RARE EARTH TREATMENT PLANT
RHONE POULENC CHIMIE AUSTRALIA PTY LTD

Report and Recommendations
of the
Environmental Protection Authority

Bulletin 352 September 1988

PROponents REPLY TO SUBMISSIONS

CROSS SECTION OF EVAPORATION POND WITH UNDERDRAIN SYSTEM

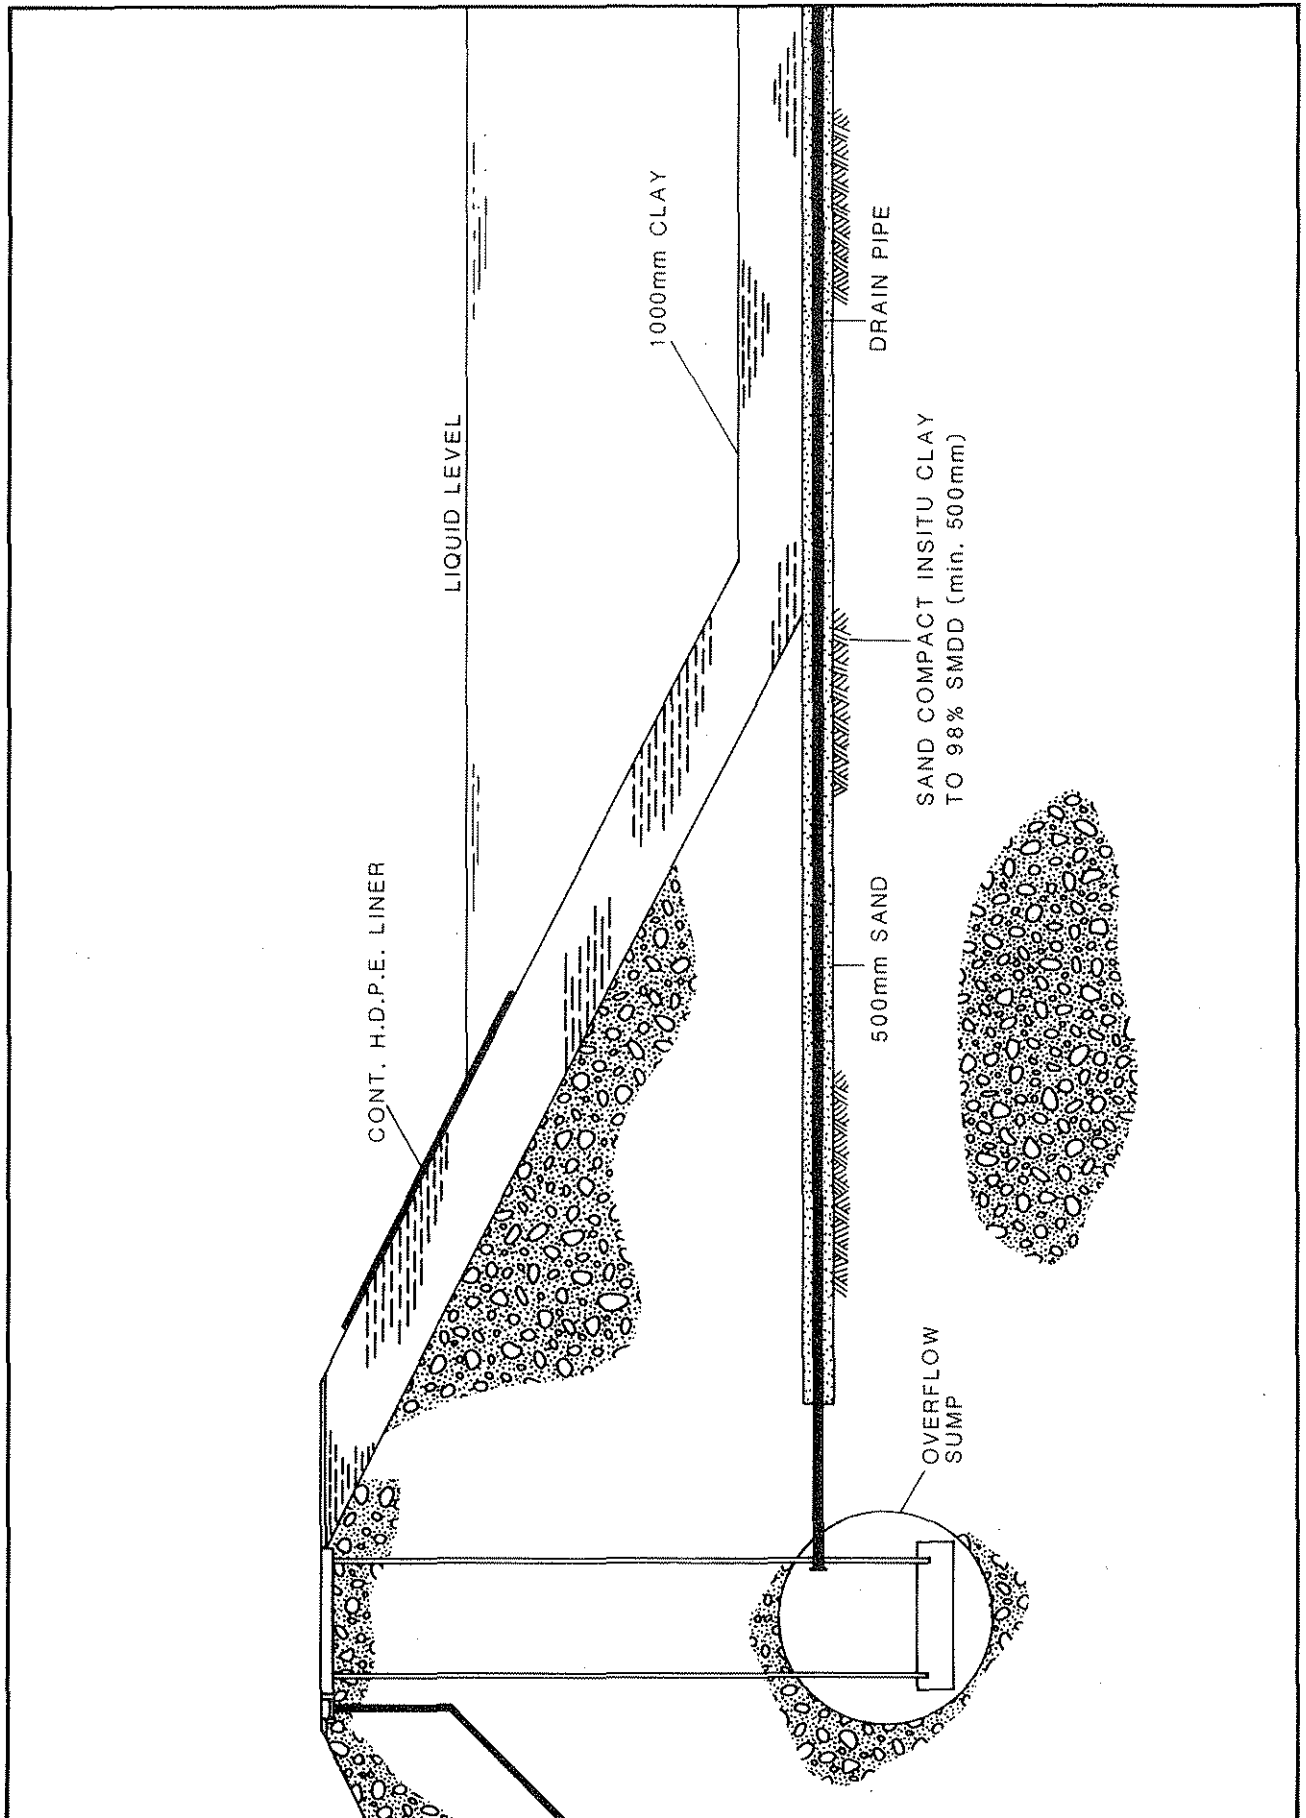
- (ix) There have been several submissions questioning the evaporation rates of the area and the pond size.
- (x) The proponent should indicate what levels of Ra 226 and Ra 228 and other radionuclides are in the groundwater and what levels of Ra 228 and radionuclides will seep into the groundwater.

The evaporation ponds that will be used for the disposal of residues from the plant will eventually occupy an area of about 30ha and extend (at the deepest point) to an elevation of about +44.5m AHD. The ponds will be underlain by an extensive underdrain system consisting of 500mm sand over a minimum of 500mm compacted in situ clay to 98% SMDD with a permeability of $5 \times 10^{-9}\text{m}/\text{sec}$ and will be sealed with a 1000mm thick compacted clay liner (Figure 3).
